FINAL DRAFT MINUTES

November 18, 2022 Standards Committee Meeting

RE: Minutes from the November 18, 2022 Standards Committee Meeting

INDIANA DEPARTMENT OF TRANSPORTATION	
TERMINAL JOINT, TYPE PCCP	
SEPTEMBER 2022	
STANDARD DRAWING NO.	E 503-BATJ-02
	Subhi Bazlamit DESIGN STANDARDS ENGINEER 6/15/2022 DATE
CHIEF ENGINEER 06/27/2022 DATE

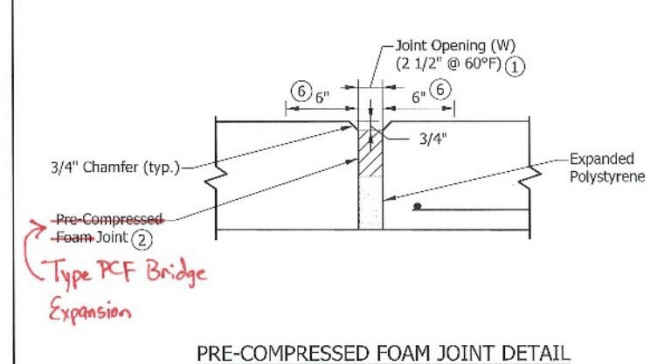
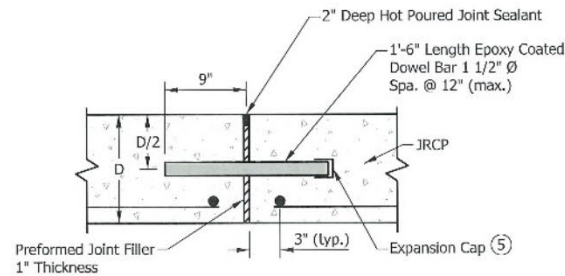
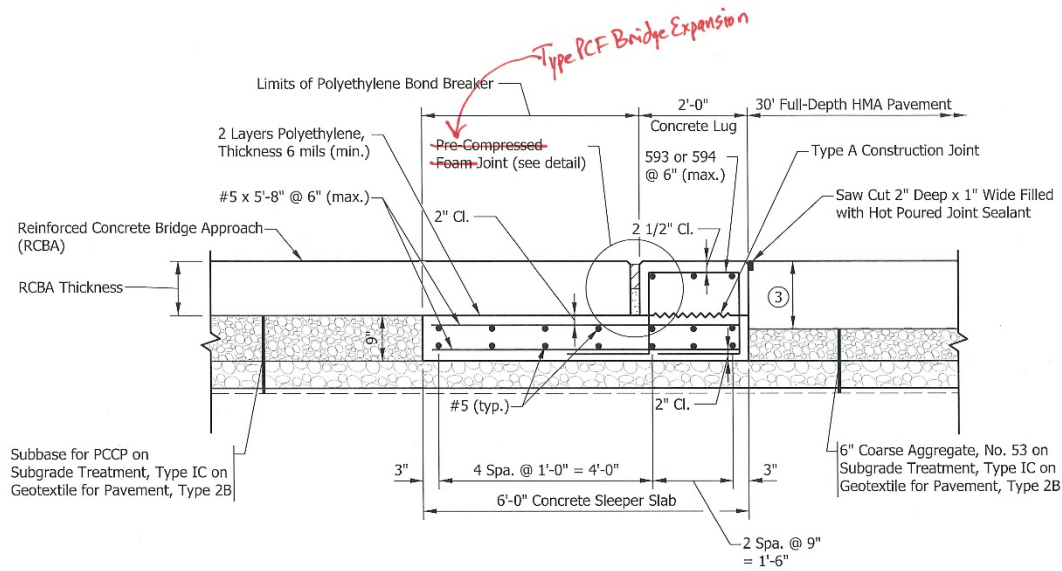
- ② The **Type PCF Bridge Expansion pre-compressed foam** joint shall be able to accommodate both the minimum and maximum joint opening widths as shown below.

E 724-BSSJ series EXPANSION JOINTS (WITH MARKUPS)

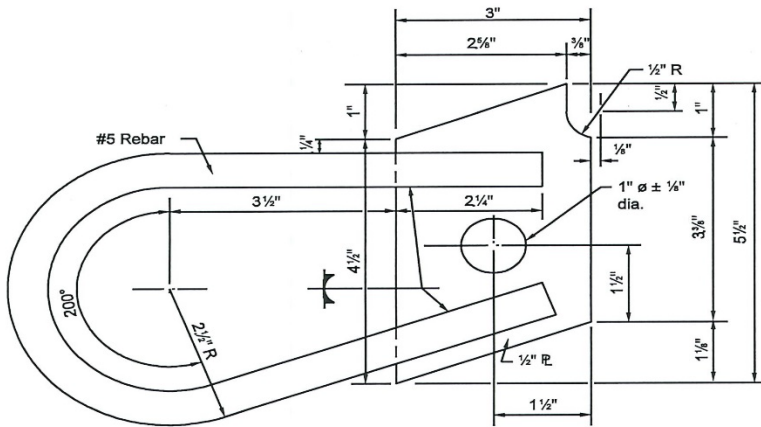
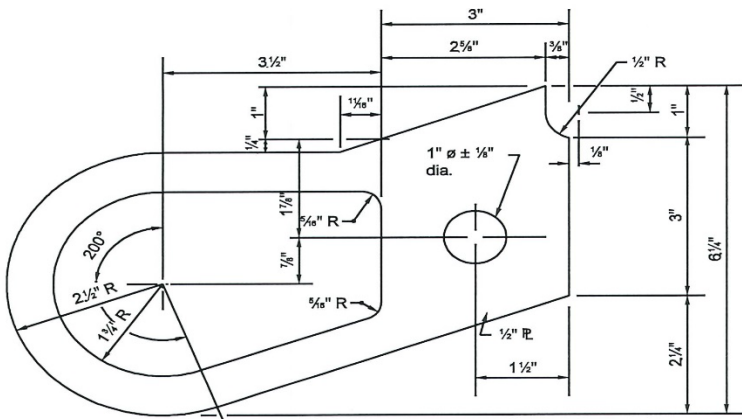
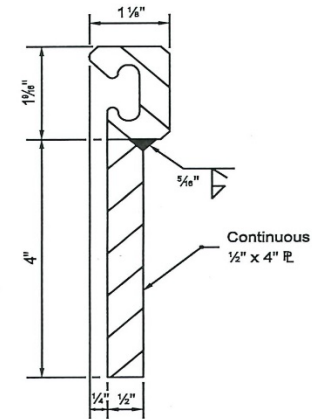
REVISION TO 2022 STANDARD SPECIFICATIONS AND STANDARD DRAWINGS

E 724-BSSJ series EXPANSION JOINTS (WITH MARKUPS)

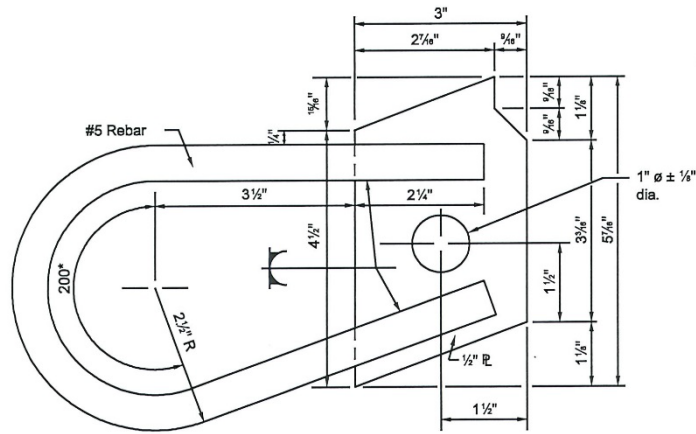
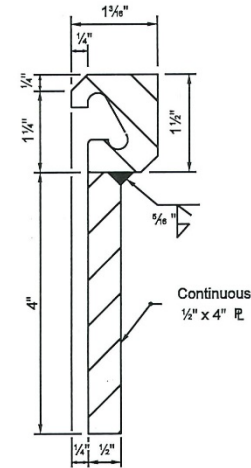
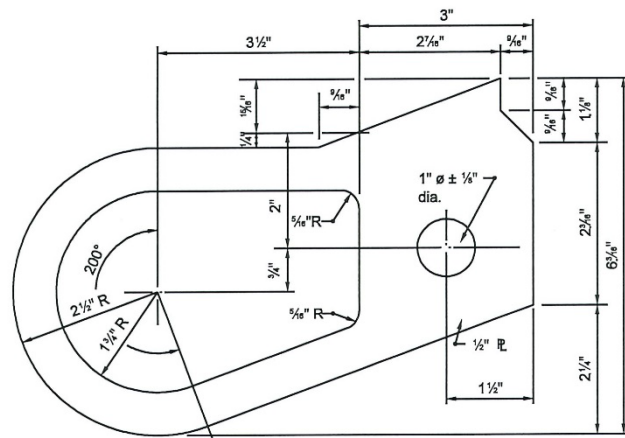
REVISION TO 2022 STANDARD SPECIFICATIONS AND STANDARD DRAWINGS

E 724-BSSJ series EXPANSION JOINTS (WITH MARKUPS)

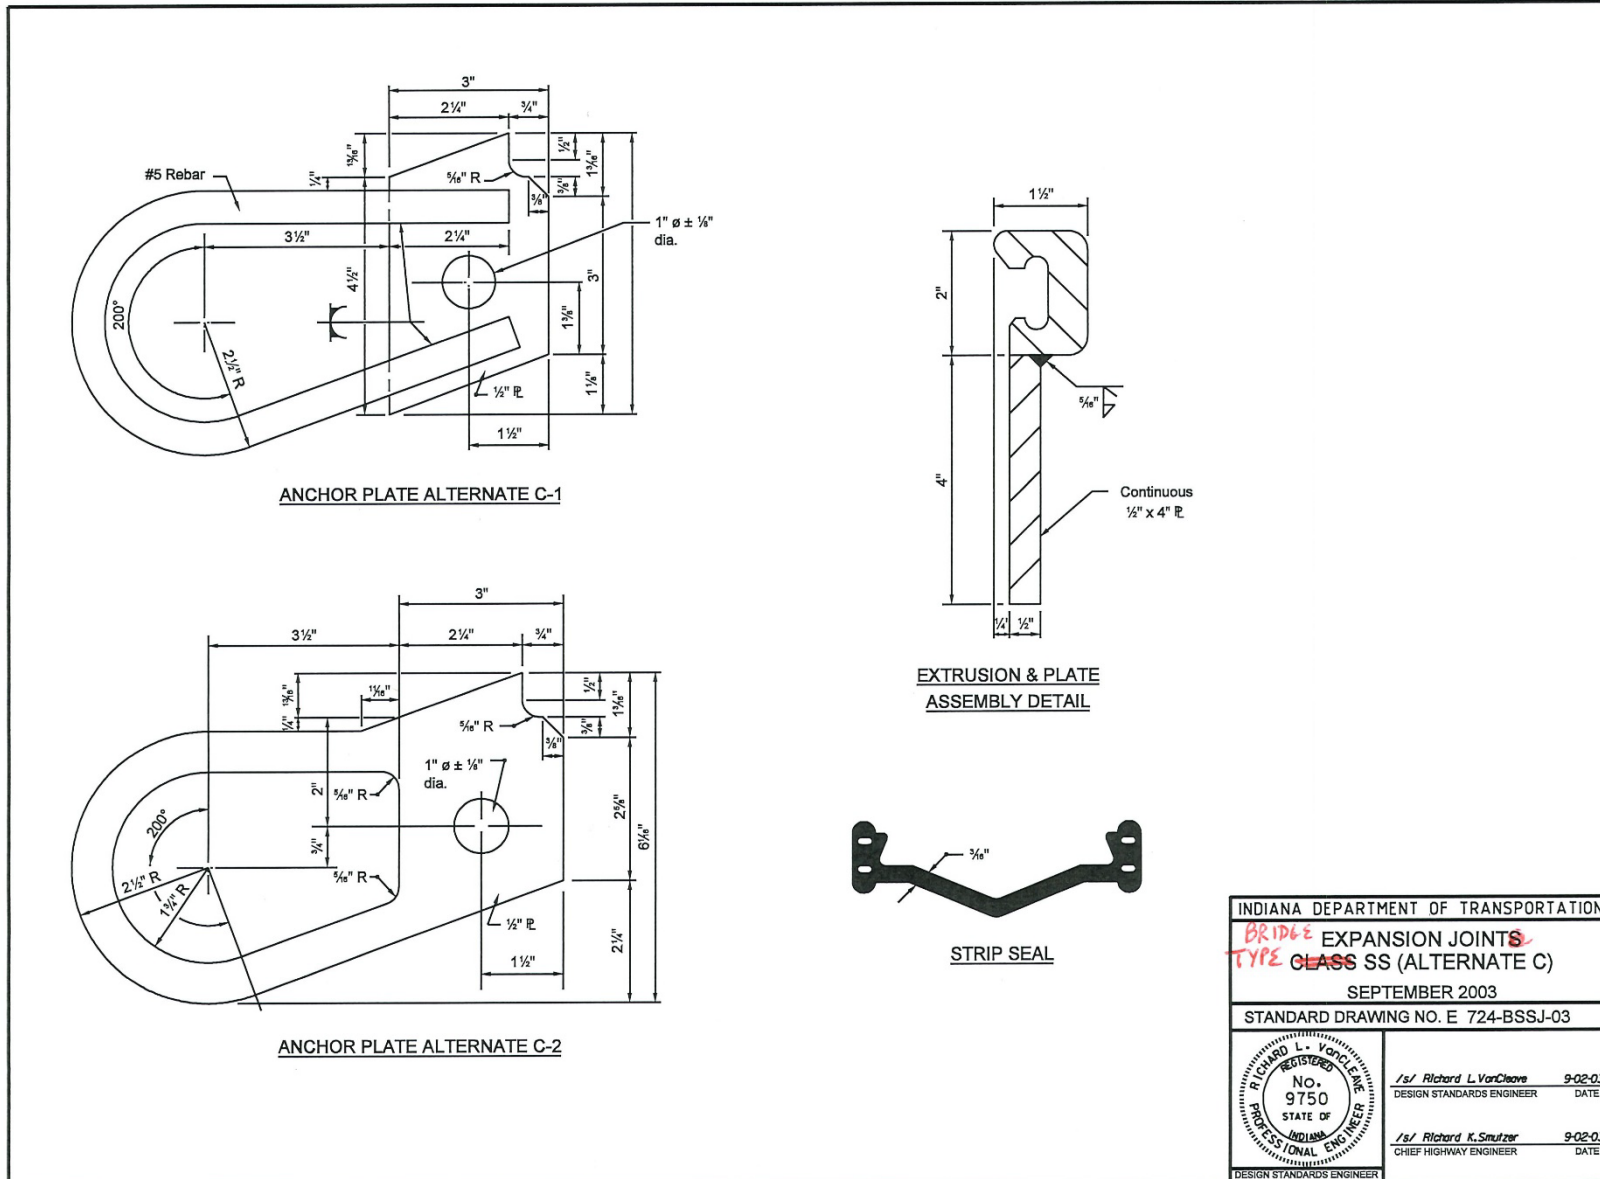
REVISION TO 2022 STANDARD SPECIFICATIONS AND STANDARD DRAWINGS

E 724-BSSJ series EXPANSION JOINTS (WITH MARKUPS)

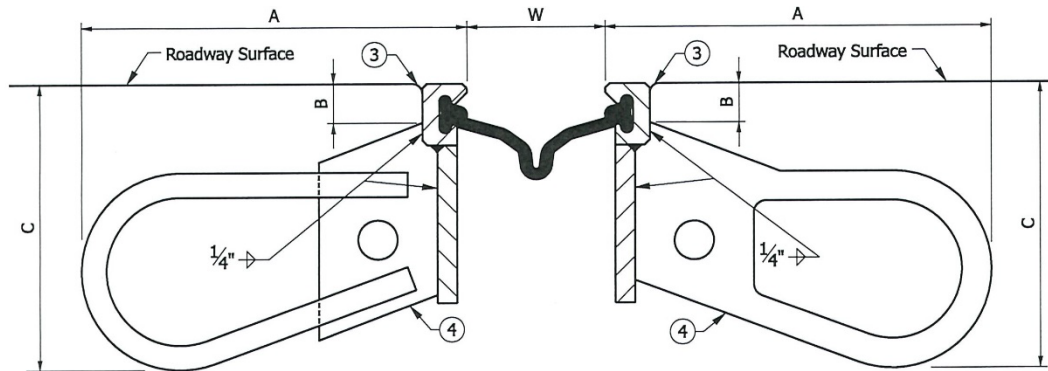
REVISION TO 2022 STANDARD SPECIFICATIONS AND STANDARD DRAWINGS

E 724-BSSJ series EXPANSION JOINTS (WITH MARKUPS)

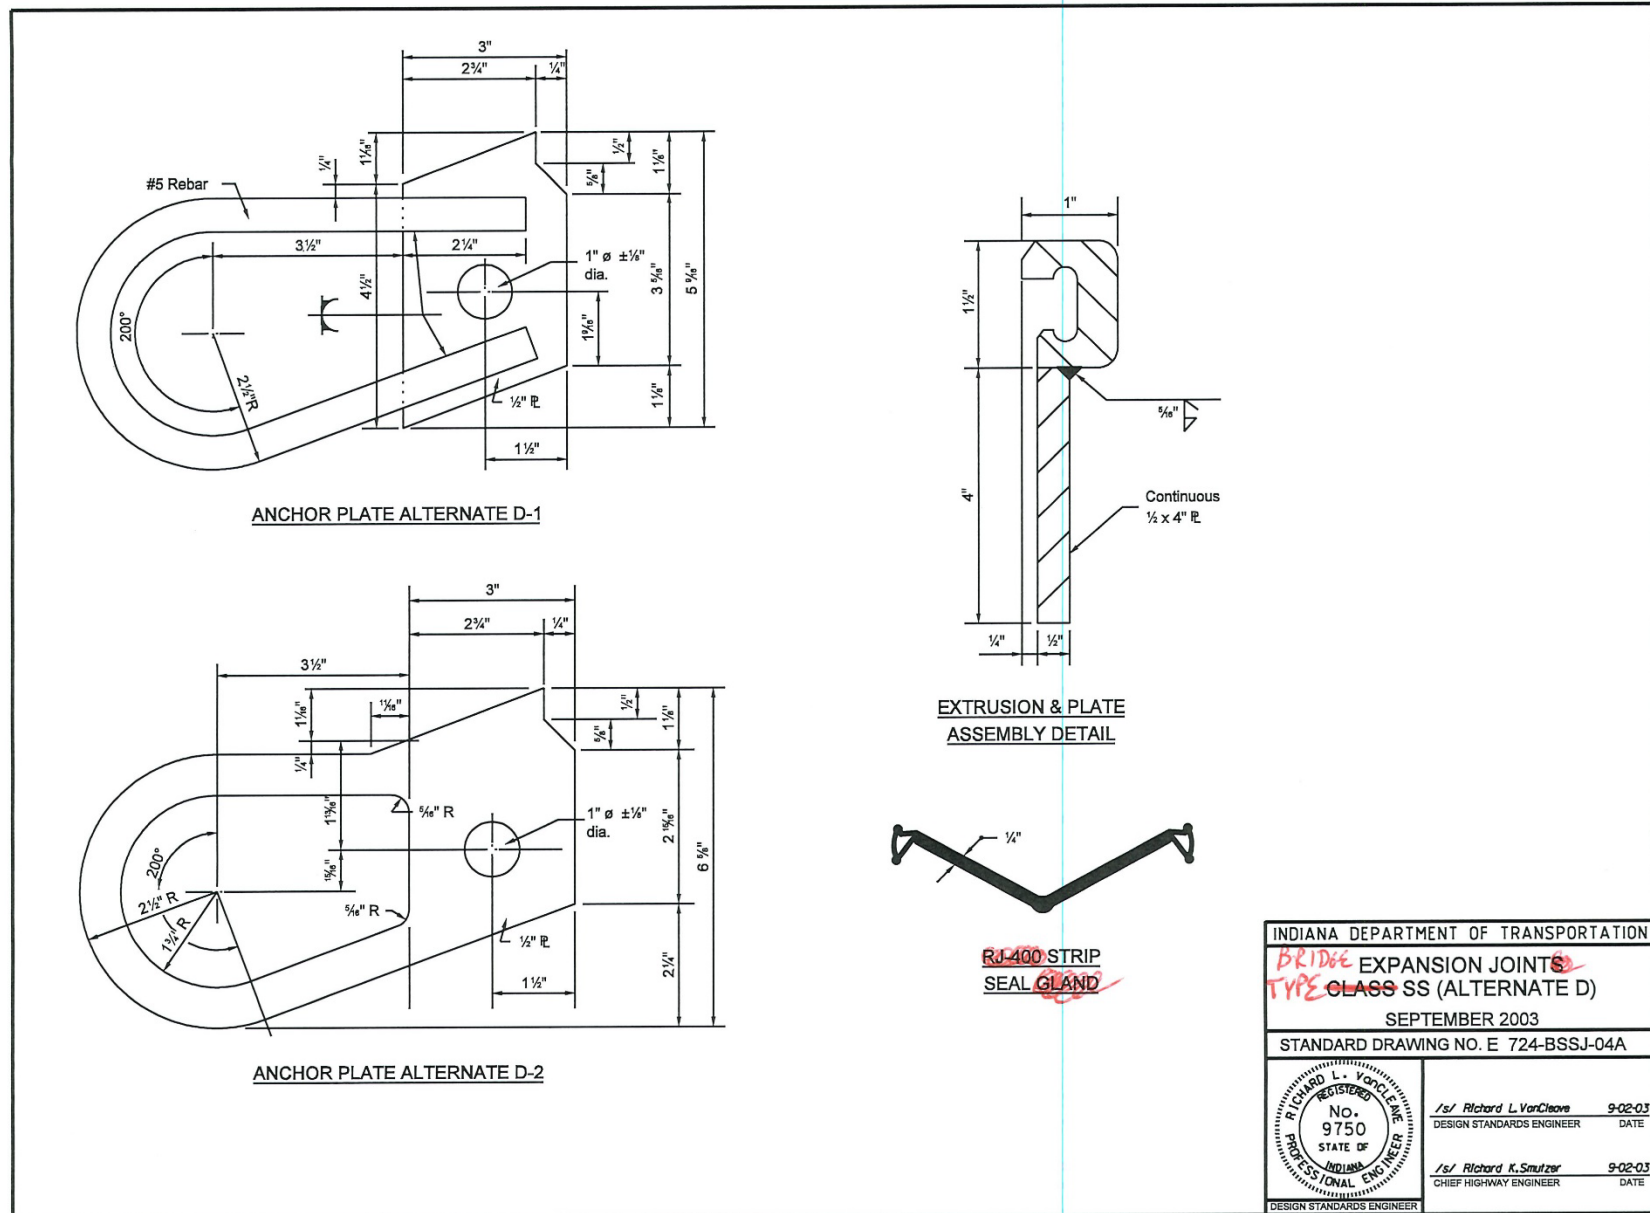
REVISION TO 2022 STANDARD SPECIFICATIONS AND STANDARD DRAWINGS
